### APPEAL SUMMARY

<b>Appeal ID:</b> 31471	<b>Project Address:</b> 3342 SE Morrison St
<b>Hearing Date:</b> 4/12/23	<b>Appellant Name:</b> Richard Dobrot
<b>Case No.:</b> B-009	<b>Appellant Phone:</b> 503-224-9656
<b>Appeal Type:</b> Building	<b>Plans Examiner/Inspector:</b> Ayush Vaidya
<b>Project Type:</b> commercial	<b>Stories:</b> 5 <b>Occupancy:</b> S2, M, R2 <b>Construction Type:</b> Type IA, IIIB, VA
<b>Building/Business Name:</b>	<b>Fire Sprinklers:</b> Yes - Throughout
<b>Appeal Involves:</b> Alteration of an existing structure	<b>LUR or Permit Application No.:</b> 23-003290-CO
<b>Plan Submitted Option:</b> pdf [File 1]	<b>Proposed use:</b> Mixed Use

### APPEAL INFORMATION SHEET

**ENLARGED PLAN** 1/4" = 1'-0"

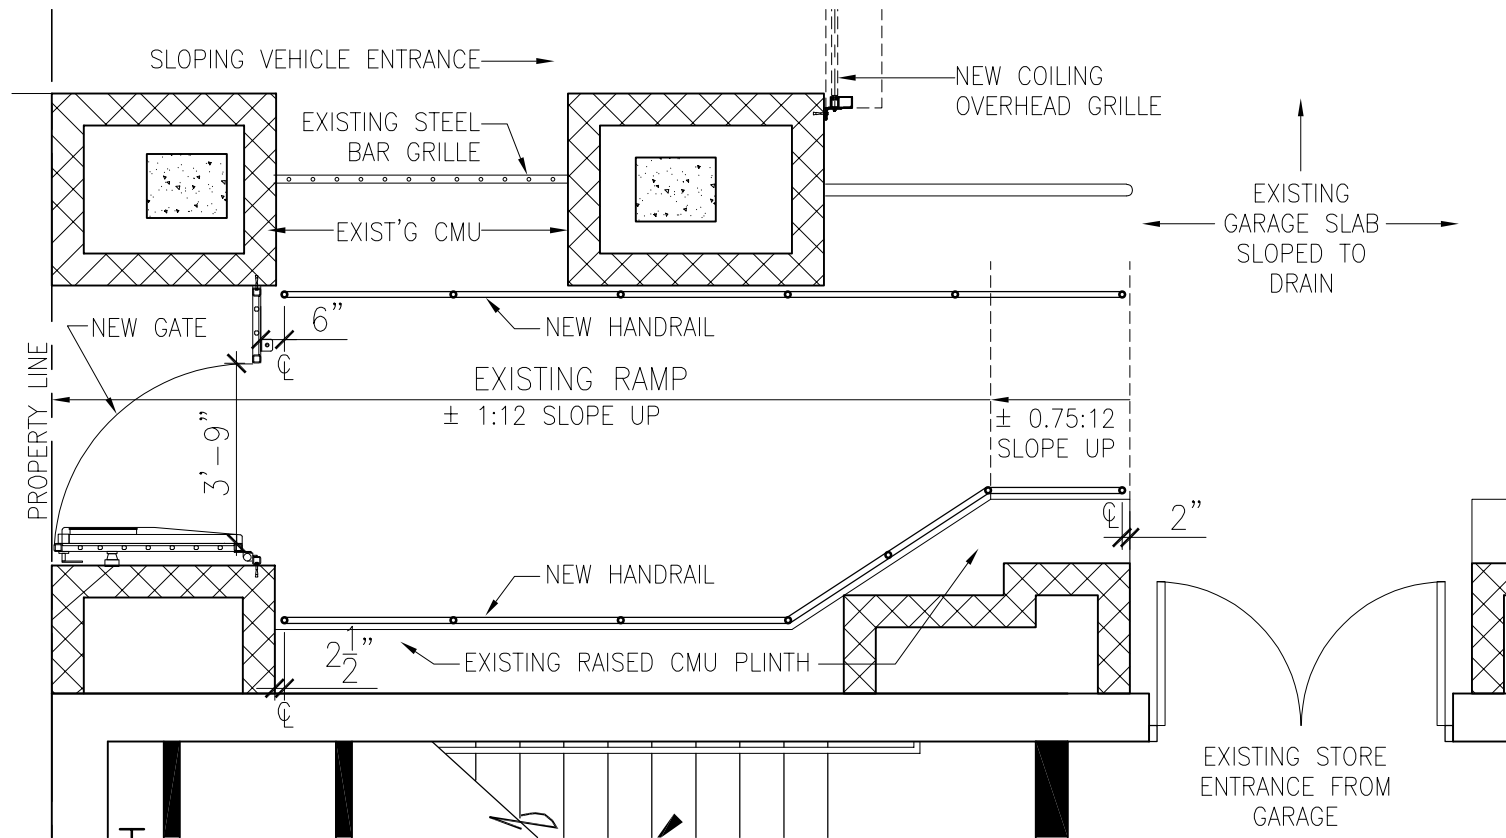
The proposed design adds a gate near the top of the existing ramp without modifying ramp. The existing ramp is slightly steeper than 1:12 slope and lacks handrails (Exhibit B-Enlarged Plan).

**Reason for alternative** The site constraints will not allow for the existing ramp to be reconfigured with landings at the proposed gate and still meet a 1:12 maximum slope without extending into and blocking a significant portion of the existing accessible entrance to the store.

The addition of handrails where none exist today, although not in full compliance, will also improve the accessibility of the exit path.

**1a. Omission of landing at security gate located near top of ramp: Hold for additional information.**

**1b. Omission of handrail extensions: Hold for additional information.**
